**ADDENDUM NO. 3**  
**NEWPORT TRANSFER STATION EXPANSION**  
**CARTERET COUNTY, NORTH CAROLINA**

**SUBJECT:** **ADDENDUM NO. 3.** Dated Tuesday, February 6, 2024, to Construction Documents for the Newport Transfer Station Expansion (REBID), dated December 8, 2023, and amended via Addendum No. 1 on January 19, 2024, and Addendum No. 2 on January 31, 2024.

**STORMWATER BMP DETAIL**

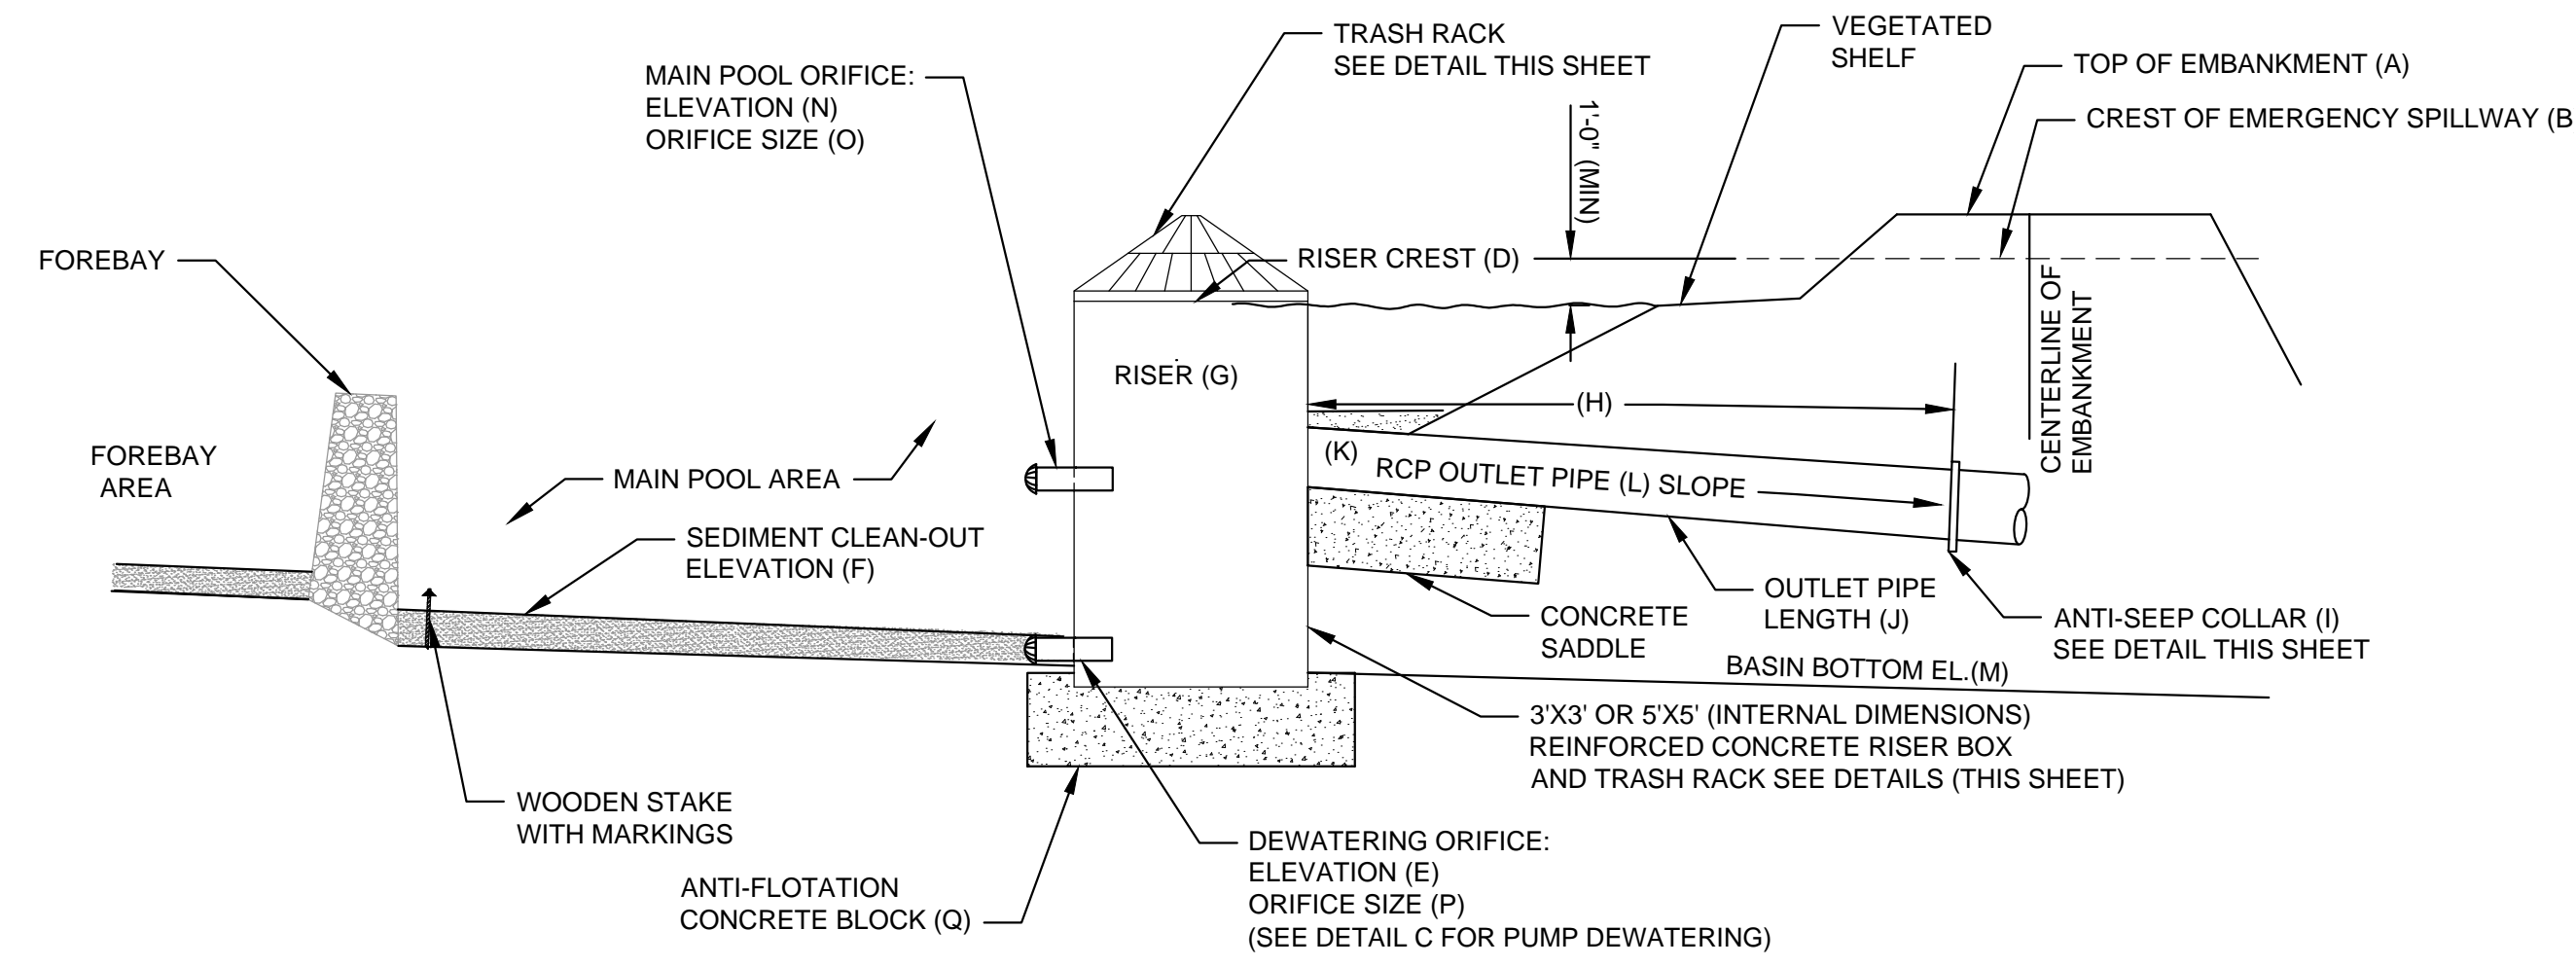
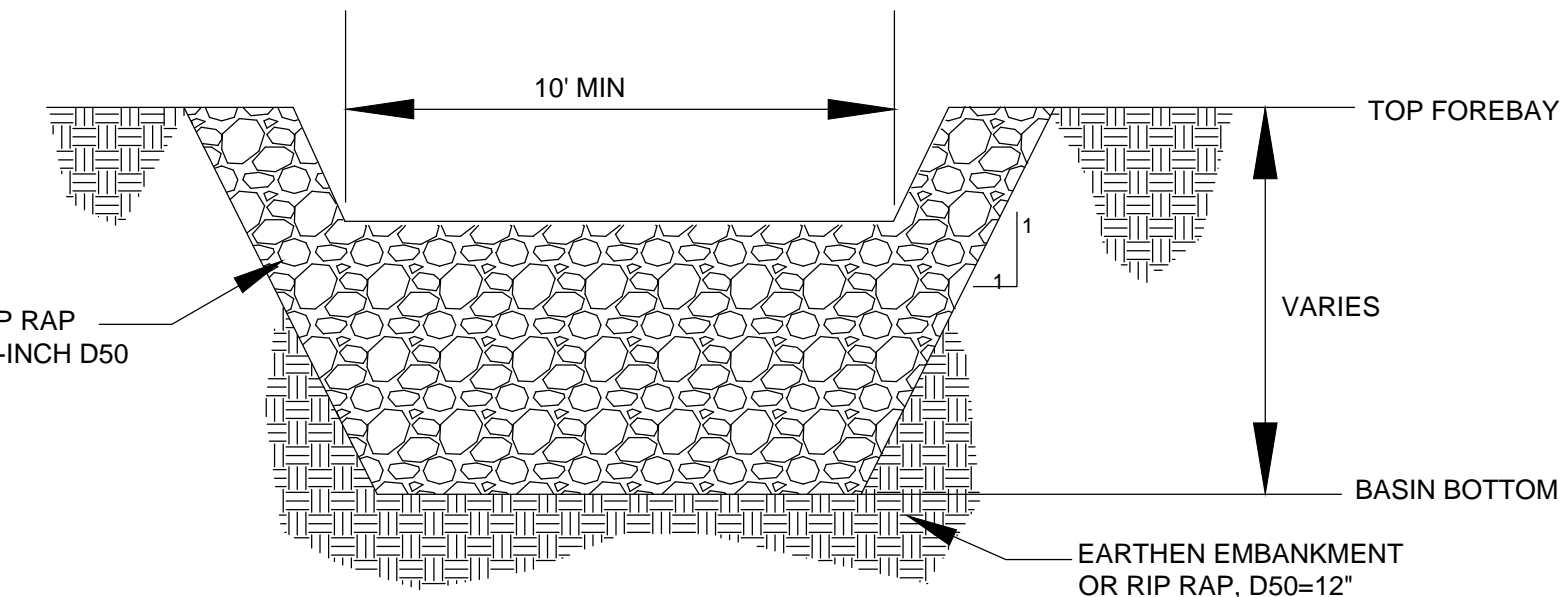
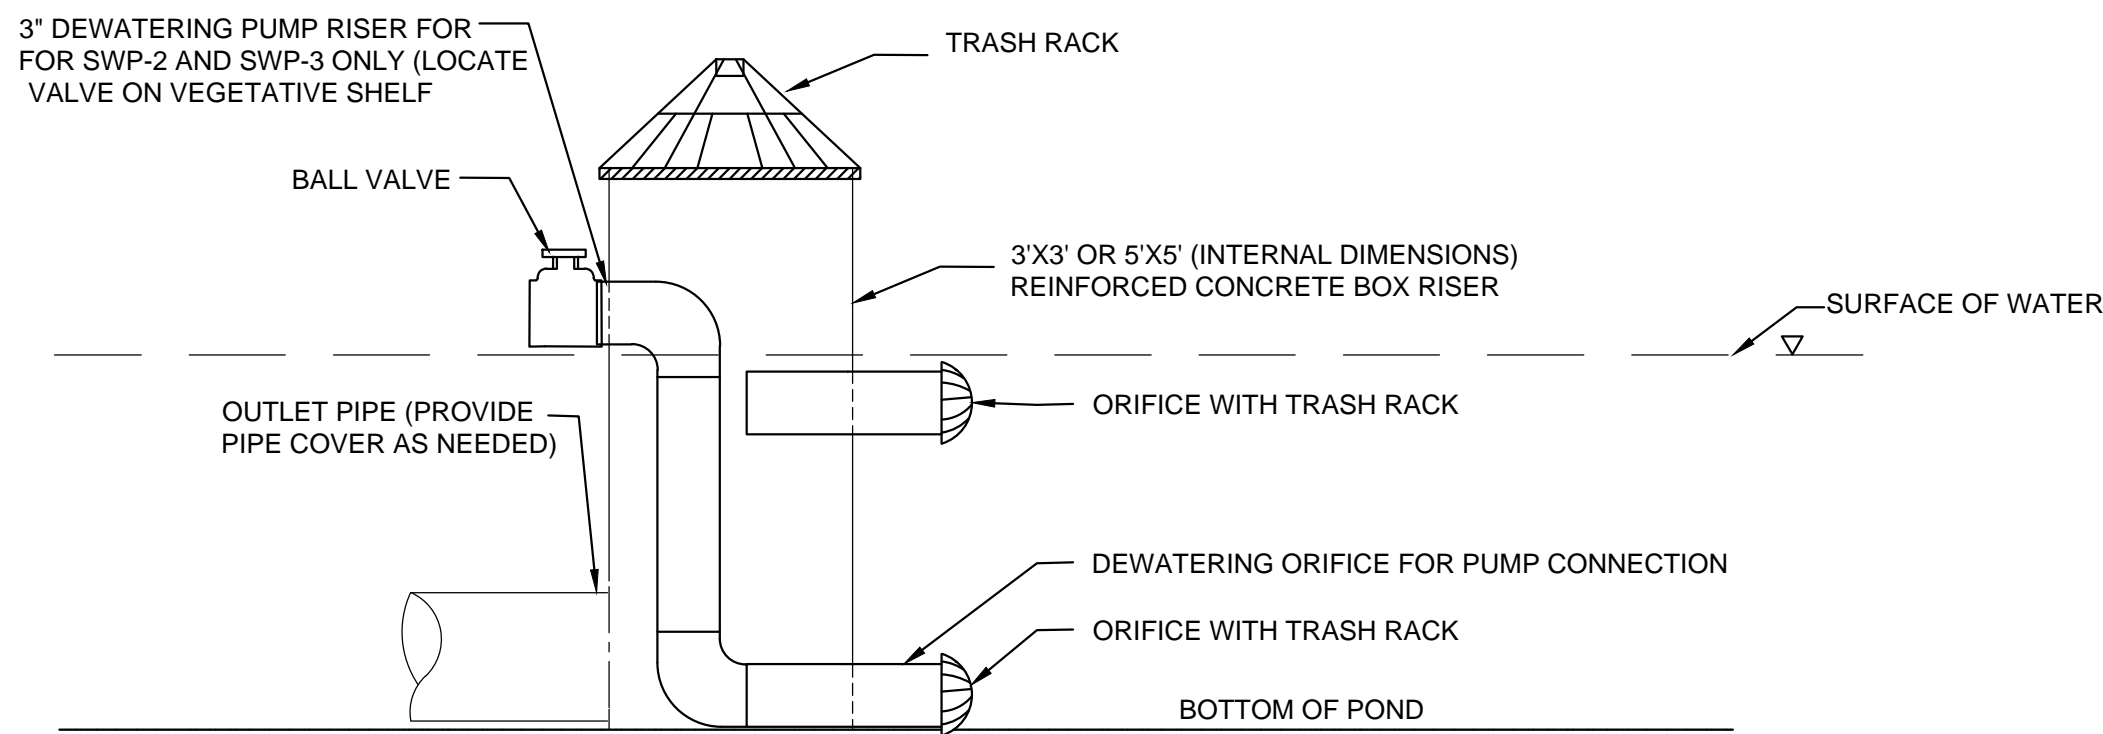
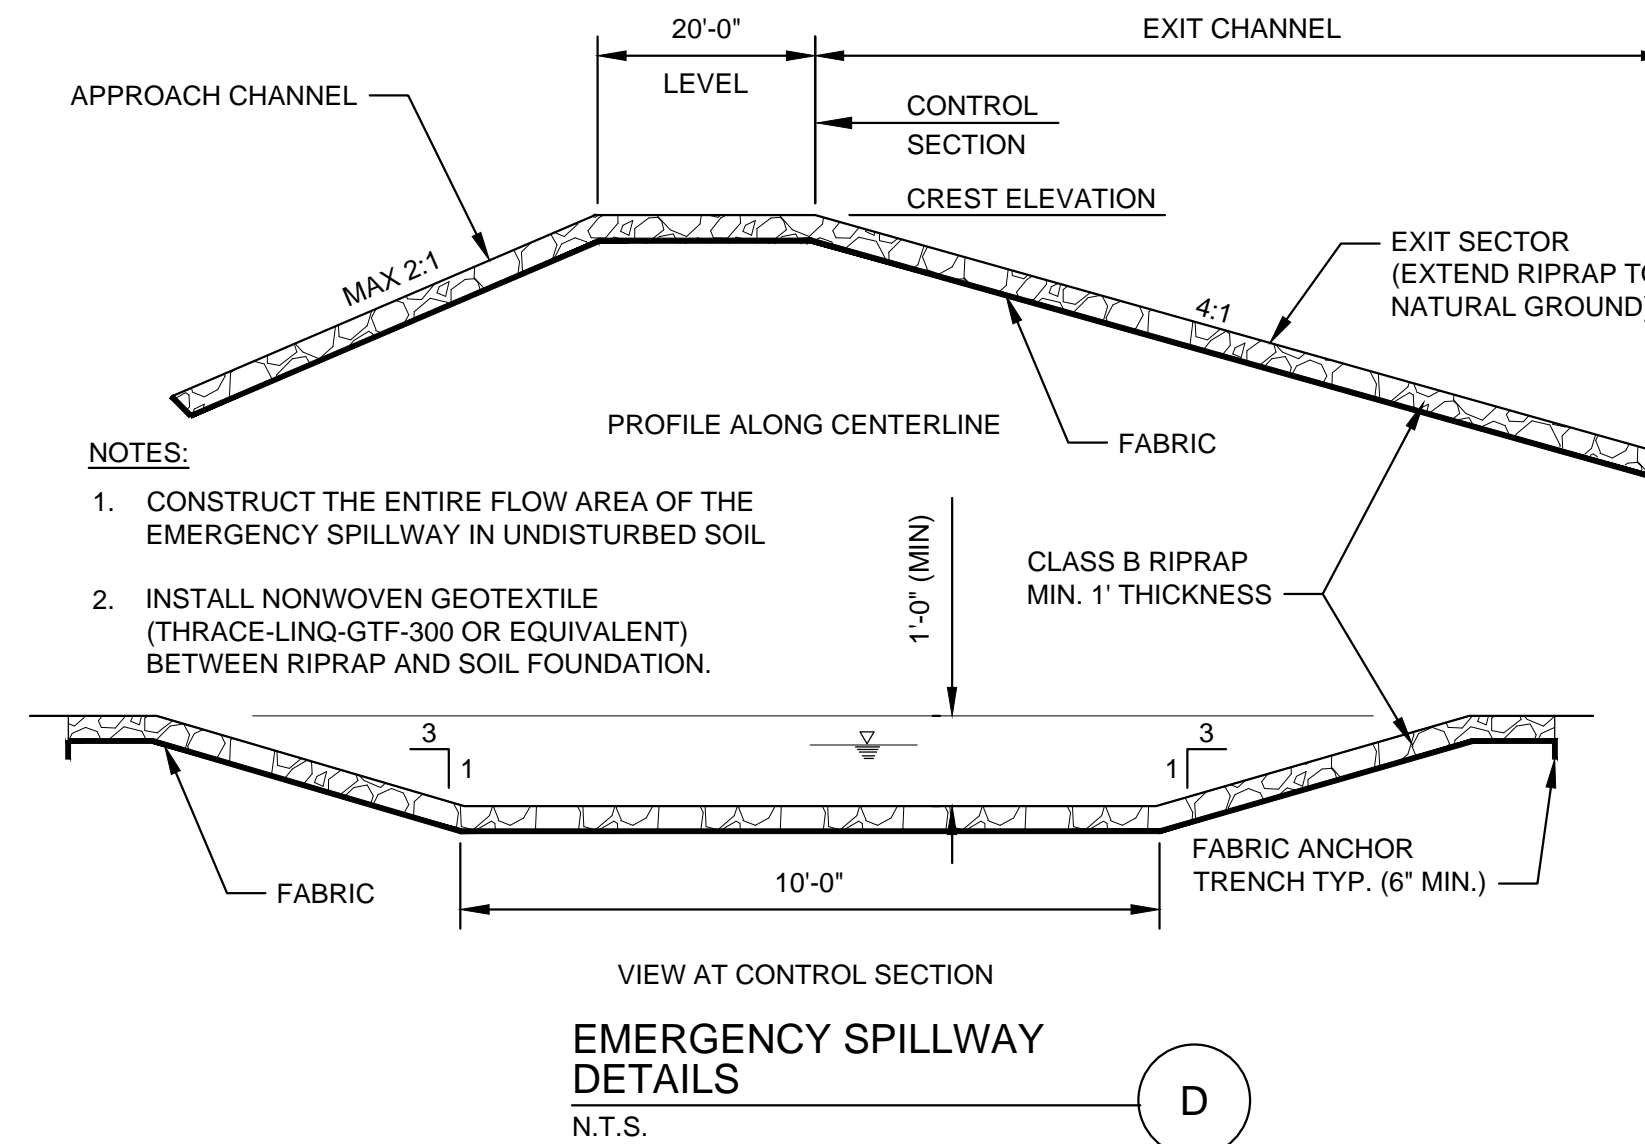
1. Based on collaborative efforts with NCDEQ Stormwater Permitting Section, two (2) new drawings were prepared showing the proposed conversion of the proposed sediment basins to wet detention ponds upon completion of the site construction. The contractor shall price this work under Bid item #32.B. Work to be completed under this item include dewatering and conversion of the proposed sediment basins and trap (as outlined in the sequencing protocol provided on new Drawing No. C-0010A), construction of the wet ponds' grades as shown on new Drawing No. C-0010A, installation of new concrete riser boxes and outlet structures for stormwater pond (SWP) 2, and SWP 3, lining of three (3) ponds (SWP-1A/SWP-1B, SWP-2, and SWP-3) with a minimum of 12 inches of low permeability (maximum permeability  $10^{-5}$  cm/sec) cohesive soil and an additional six (6) inches of amended top soil to support vegetative growth, installation of a vegetative shelf consisting of at least three (3) diverse species of herbaceous,
